UNITED STATES ENVIRONMENTAL PROTECTION AGENCY, REGION 2

Re: Notice of Site Visit Findings and Proposed Actions Pursuant to Sections 301(a) and 402 of the Clean Water Act; 2015 MSGP Tracking Number PRR053093

I. Findings of the July 21, 2017 Site Visit

Picture 3

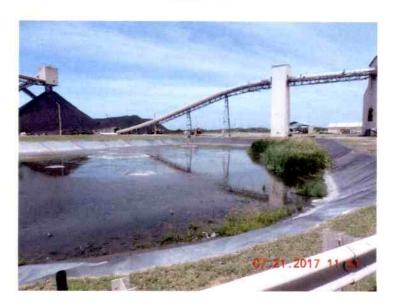
- c. Finding 3 (Picture 3 below depicts this observation):
 - The storm water pond was not properly maintained, and was covered with significant vegetation growth.

⇒ Remove all vegetation from the storm water pond
